## Field Safety Notice

### Urgent Medical Device Correction - ISIFA2017-02-C

*Proper use of da Vinci® Xi EndoWrist Stapler Release Kit*

**Figure 3:** If necessary, press emergency stop button

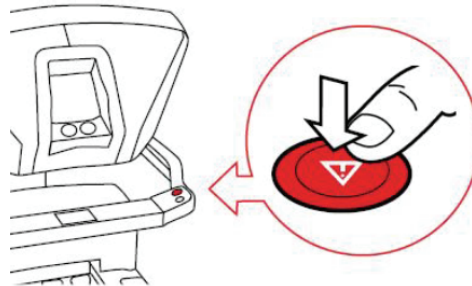
1. Obtain the Stapler Release Kit and open its sterile wrapping.
2. If the system is not faulted, press the Emergency Stop button on the Surgeon Console. Do not recover the fault.
